# Product Change Notification

## 111916 - 00

**Change Notification #:** 111916 - 00  
**Change Title:** Intel® Itanium® Processors, PCN 111916-00, Product Marking, Removal of top substrate side human readable L-marks and relocate bottom substrate side L-marks to the IHS lids  
**Date of Publication:** January 02, 2013

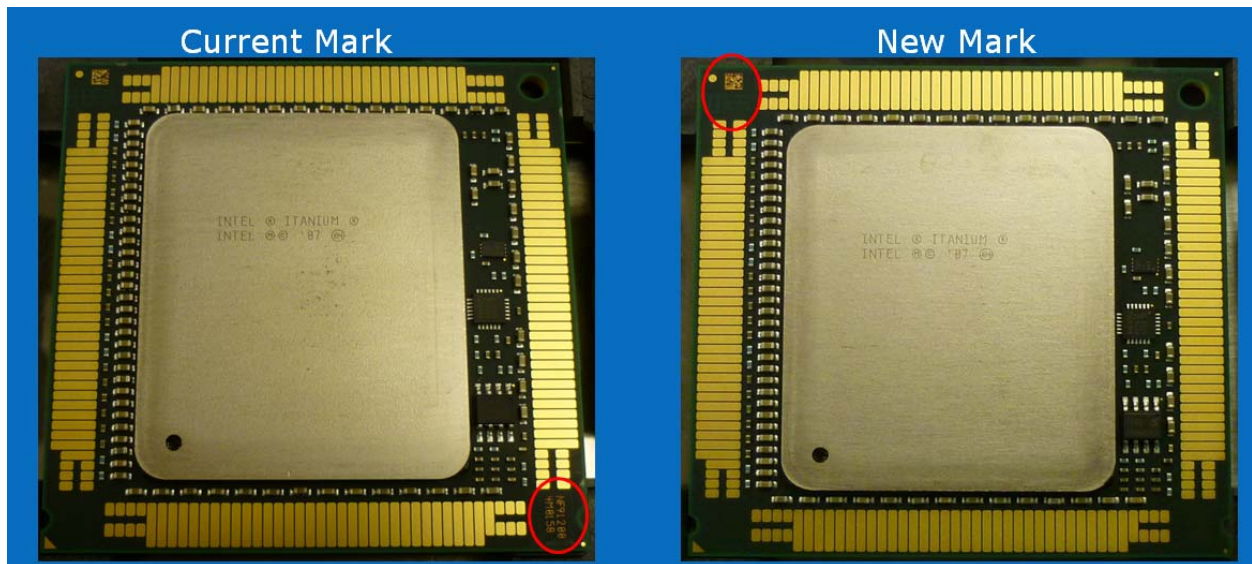
Intel will be eliminating the human readable mark on select Intel® Itanium® Processors. Customers will notice that the human readable mark in the lower right corner and the data it contains is now located in the 2D mark in the upper left hand corner as shown in the pictures below:

Substrate bottom side marks will be relocated to IHS (blue square).

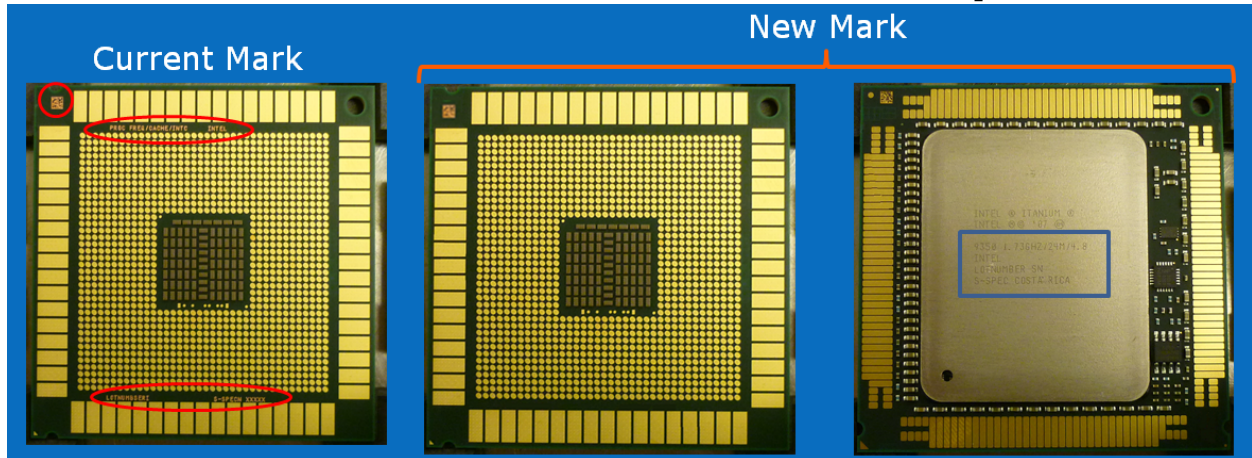
Customers will notice that the IHS lid mark has 5 group lines instead of 2 lines (current mark) and the bottom side has the 2D matrix (with the lot number on it). Four group lines will be relocated to the top IHS eliminating redundant information. Customer assembly process will not be affected regarding the tooling set up as no changes are being made to the unit dimensions, its materials or assembly process. No changes to ordering codes. See image below:
